X-SECTION

^3H CRIB 216-S-25

^3H W23-10

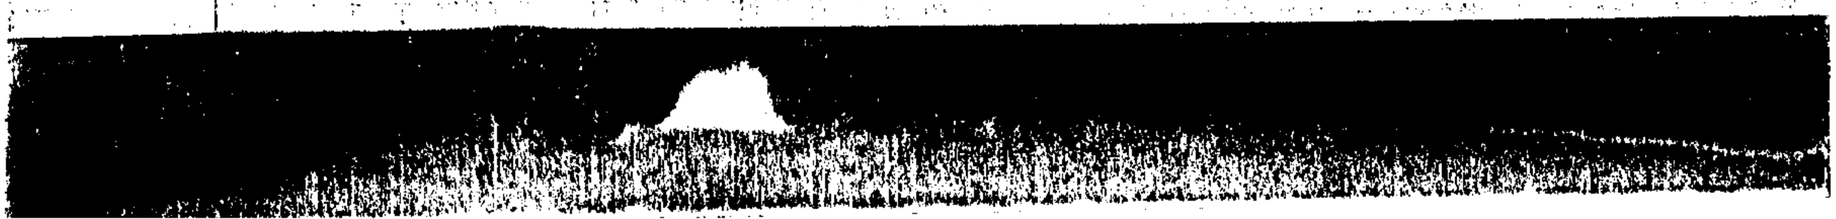
- WATER-~~TABLE~~ LEVEL ELEVATION
- WL ABOVE SL OR BLS ?
- IN., FT., M. ?
- SPACE BETWEEN 200 WEST
- WHAT ARE STRANGE LINES ON INSERT ?

- WHITE OUT ON LINE AT 10^3

- IS THE WELL USED TO MONITOR THE 216-S-25 CRIB ? IF SO, IT SHOULD HAVE A NUMBER OF SOME TYPE.
- FIGURE HARD TO READ. MAYBE IT WOULD BE EASIER IF O's & Δ's WERE JOINED WITH LINES
- NEEDS LOCATION MAP
- PERHAPS TITLE WOULD BE EASIER TO UNDERSTAND IF IT SAID SOMETHING LIKE THIS: ^3H LEVELS IN DISCHARGE STREAM TO CRIB 216-S-25 AND NEARBY MONITORING WELL
